TOWN OF CORTLANDT PLANNING BOARD

WORK SESSION.....JULY 1, 2025 6:00 PM

MEETING AGENDA.....PLANNING BOARD
TOWN OF CORTLANDT
6:30 TUESDAY EVENING*
JULY 1, 2025

PROPOSED LEAF-OFF

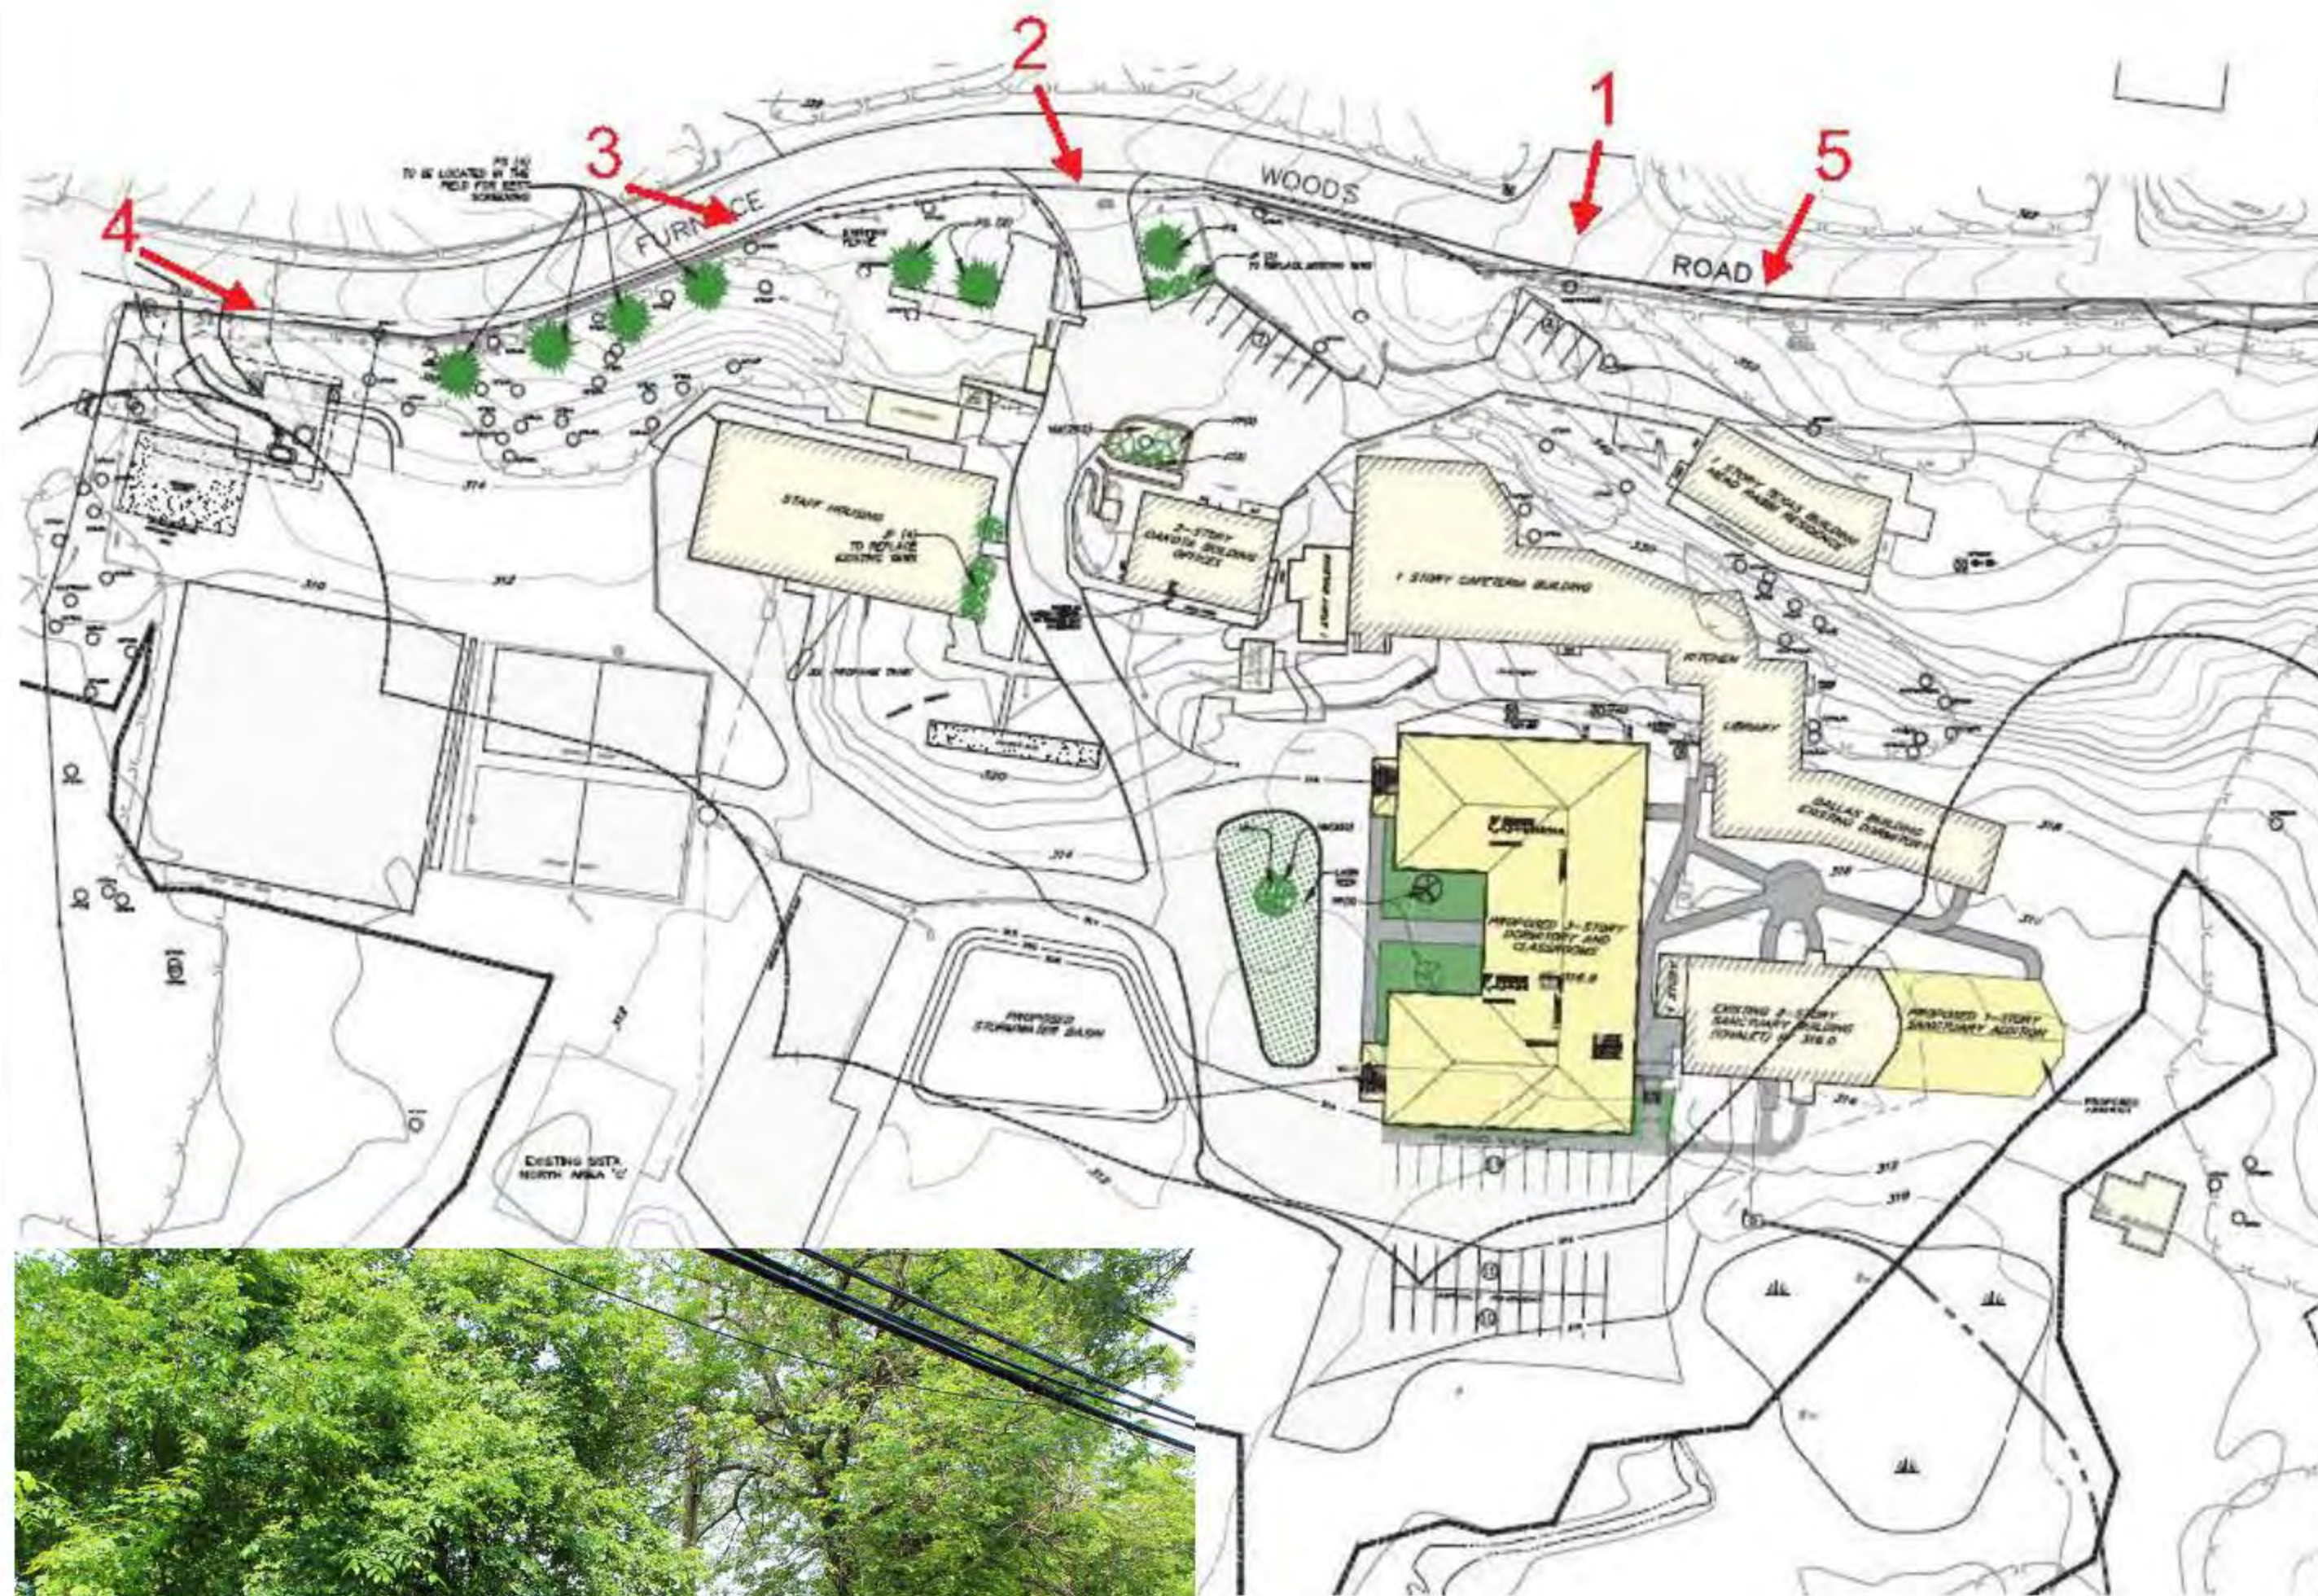
2. **Visual Impacts:** At their May meeting, the Planning Board requested the applicant provide views of the new dormitory building from the nearby public road. Views should be shown from multiple points along Furnace Woods Road, in both leaf-on and leaf-off conditions. In addition to the site line shown on Sheet 7, we suggest capturing views southbound from the vicinity of 165 Furnace Woods Road, northbound from the vicinity of 130-136 Furnace Woods Road, and from the site entrance.

PROPOSED FRONT ELEVATION

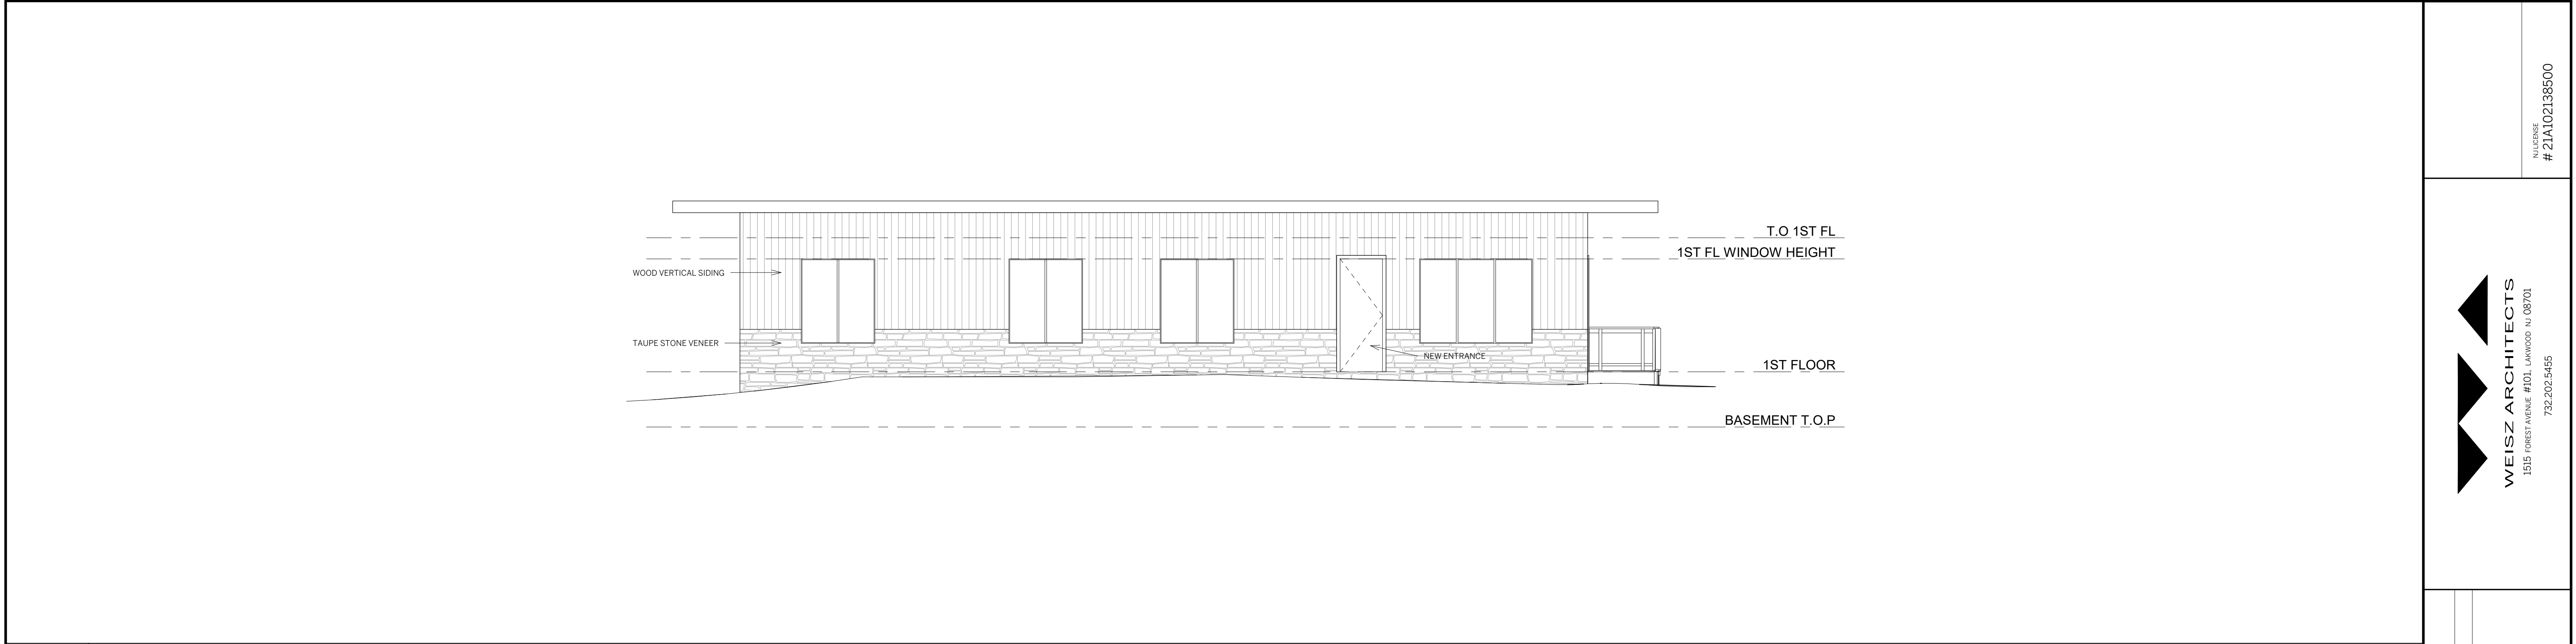
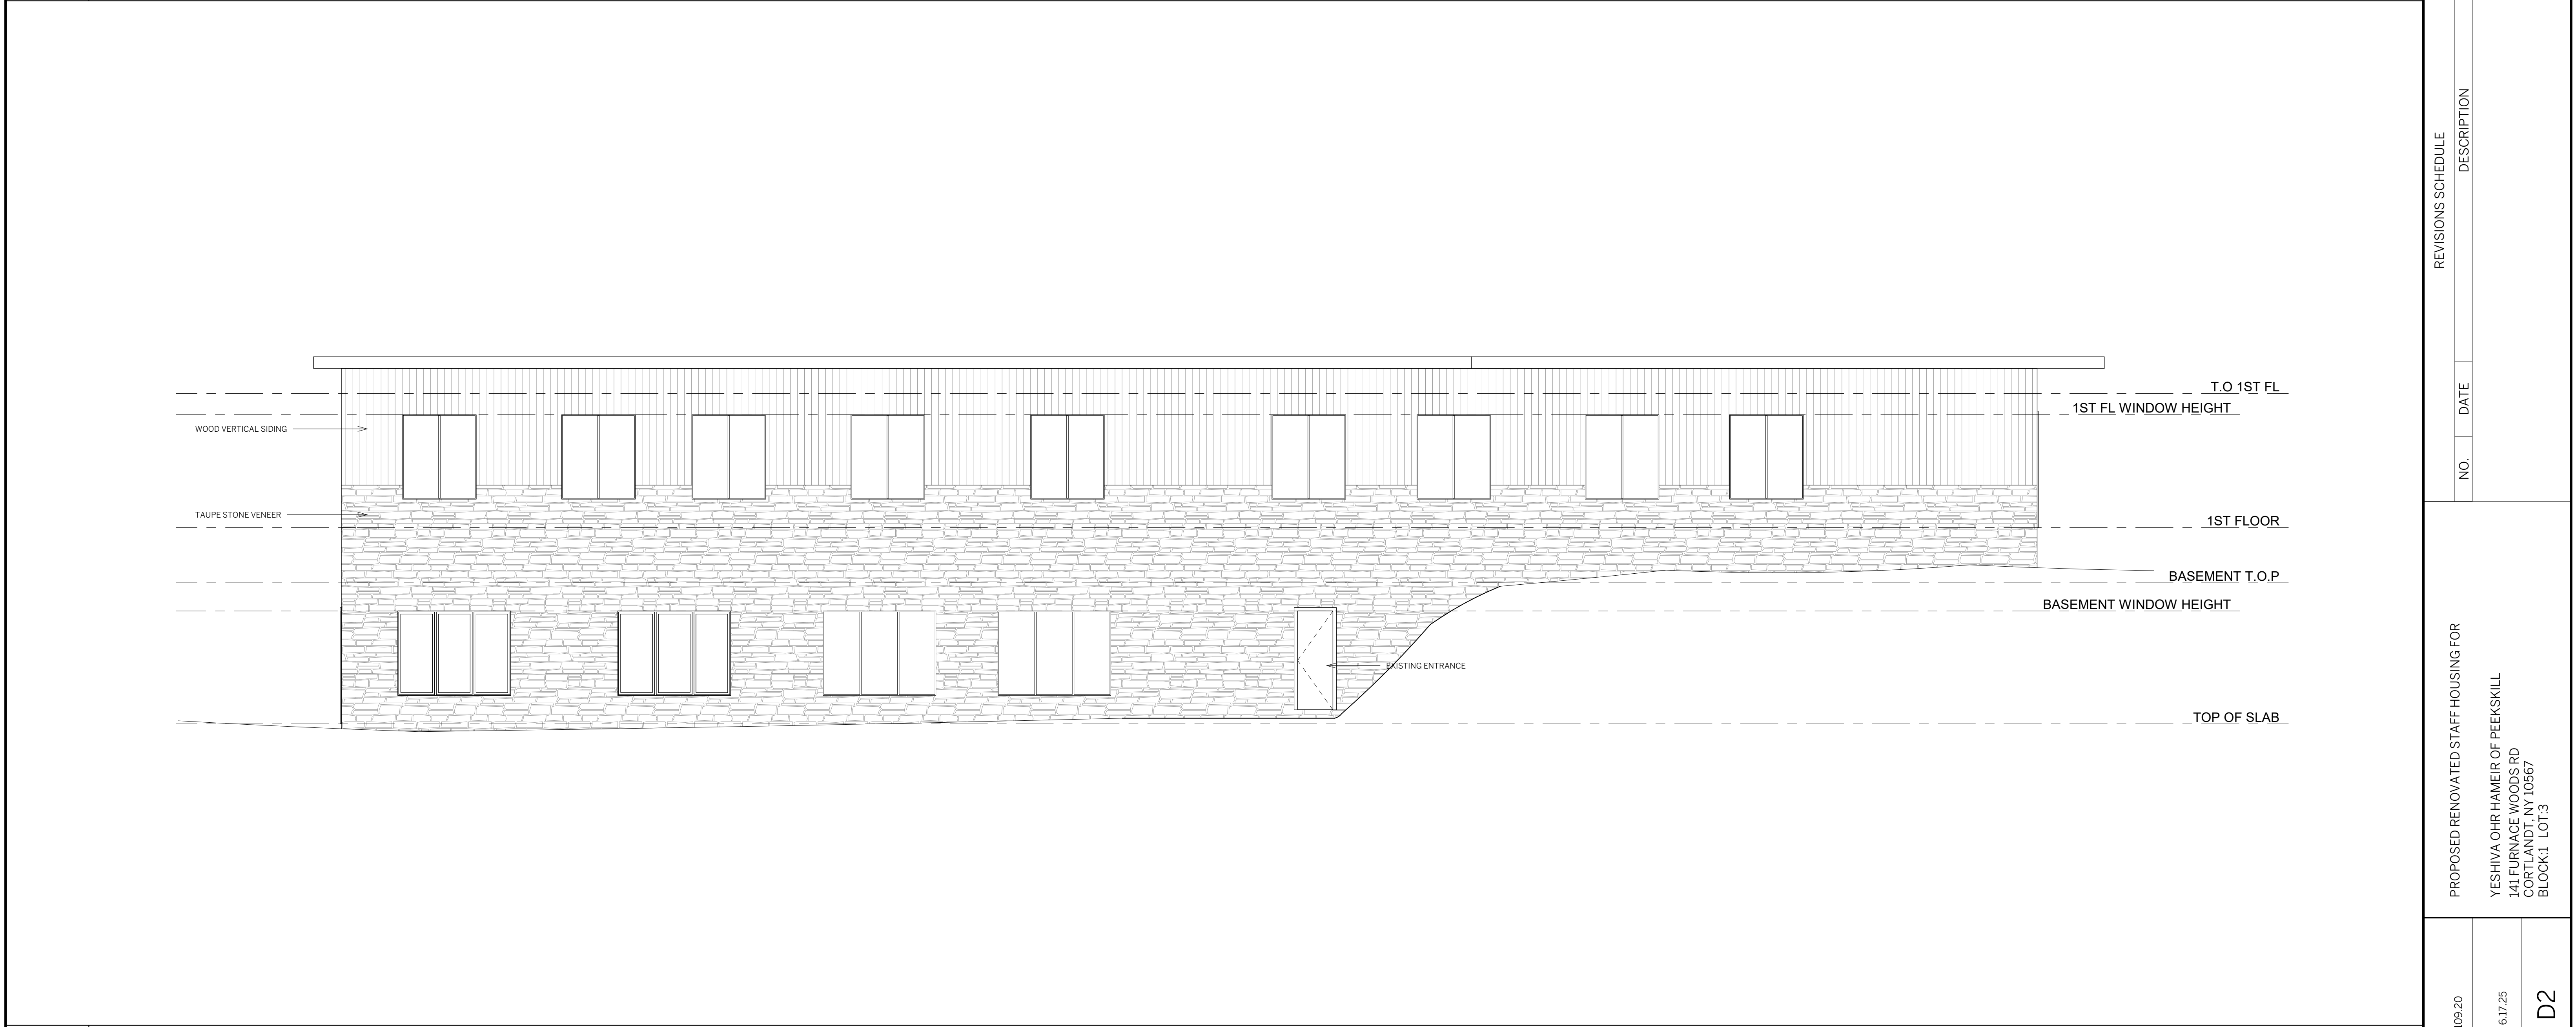
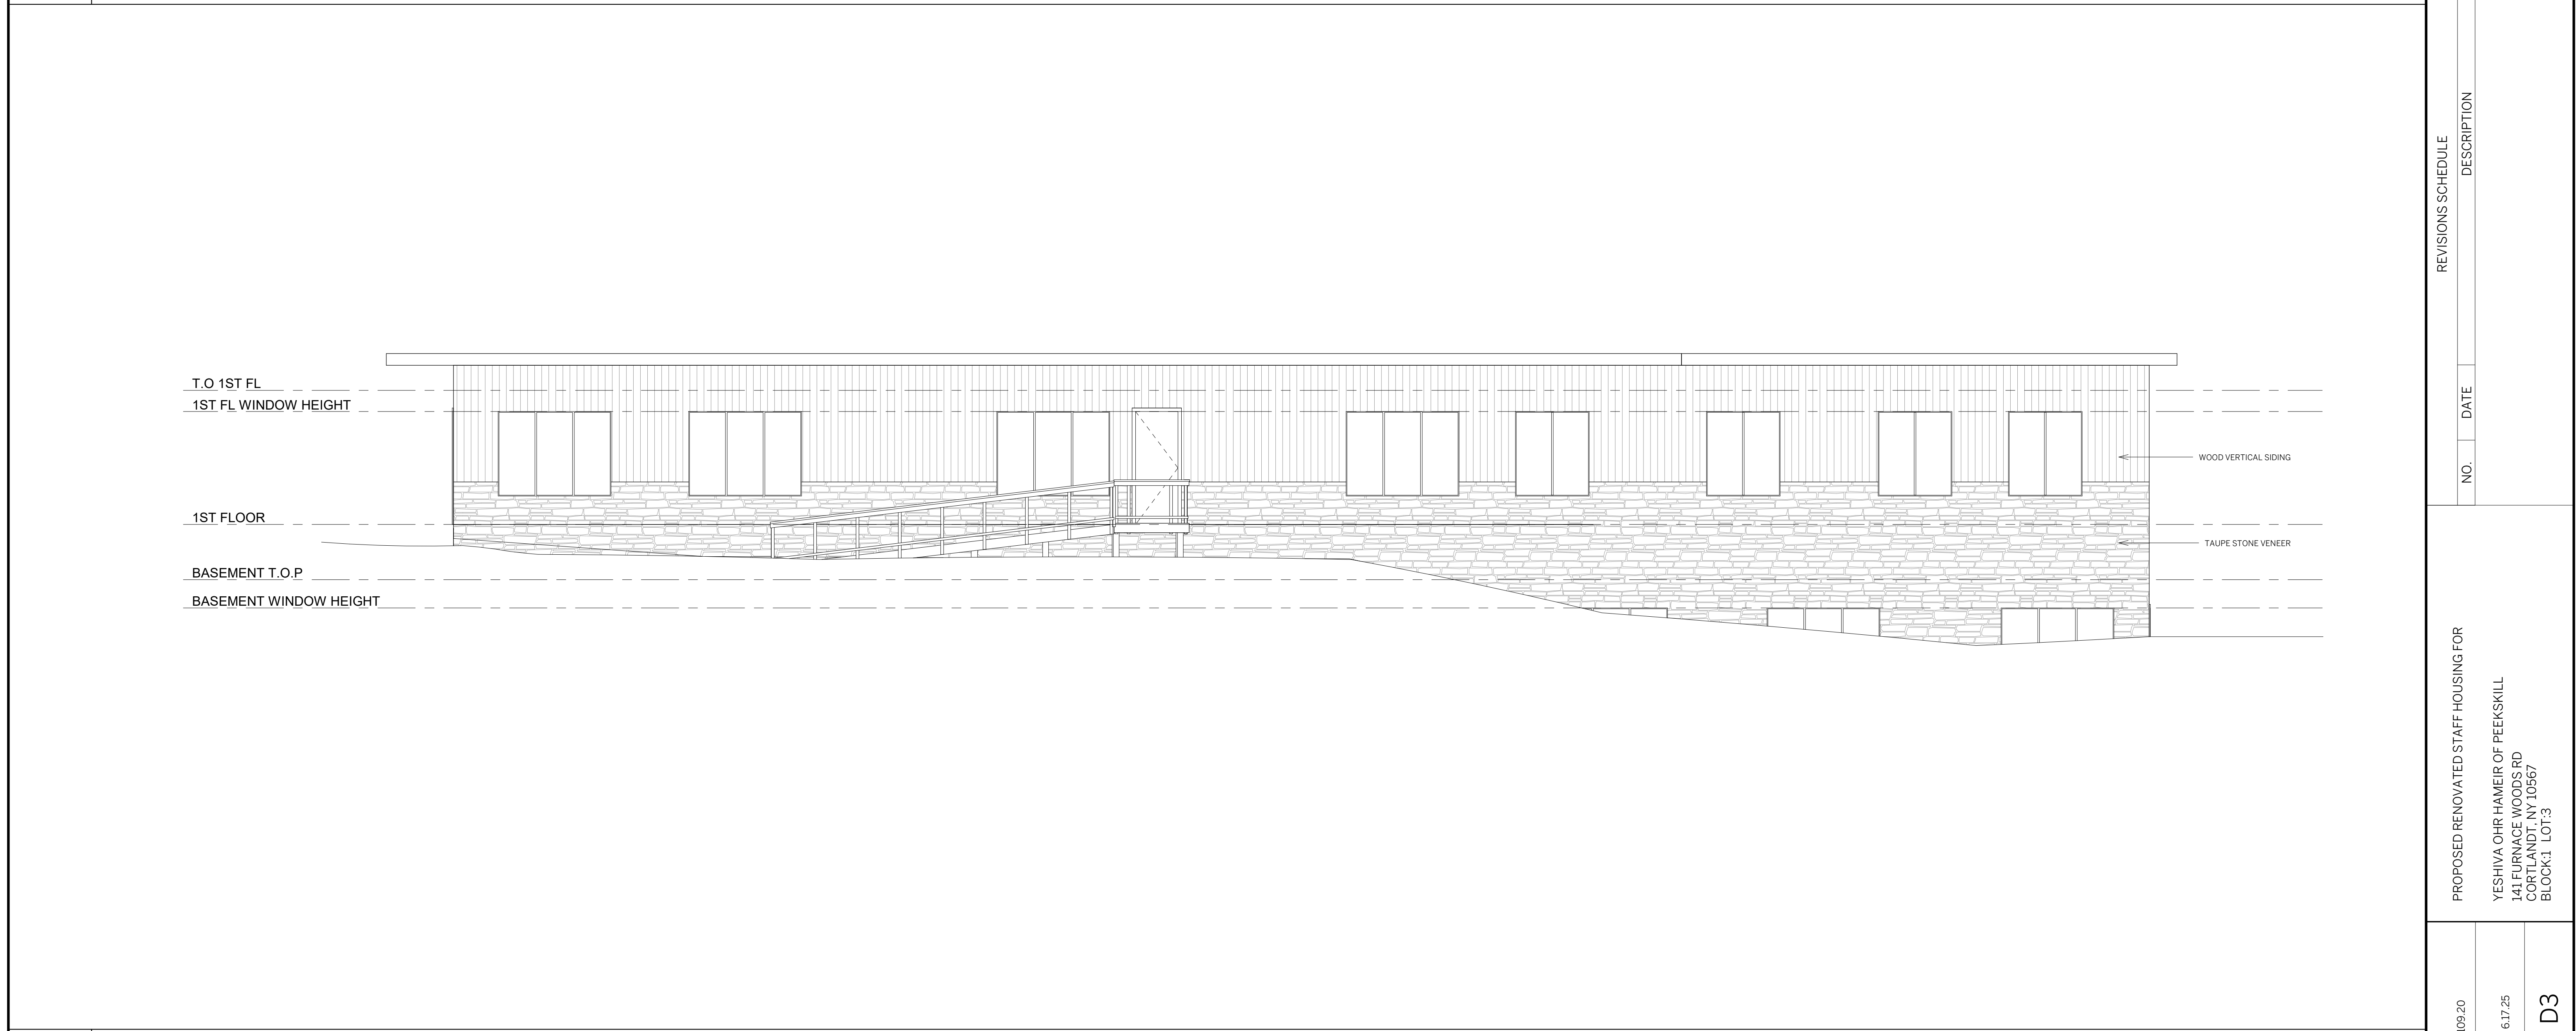
3. **Architecture:** Calculations for the overall building height of the proposed dormitory building should be shown on the plans, and the bulk table on Sheet 3 of the site plan set updated to reflect the correct proposed building height; it states a height of 30 feet which seems unlikely given that the architectural drawings show a static height of over 46 feet to the midpoint of the roof slope. For the staff housing building, the applicant should provide clarification as to whether any exterior changes are proposed, and include information about the proposed exterior materials/colors.
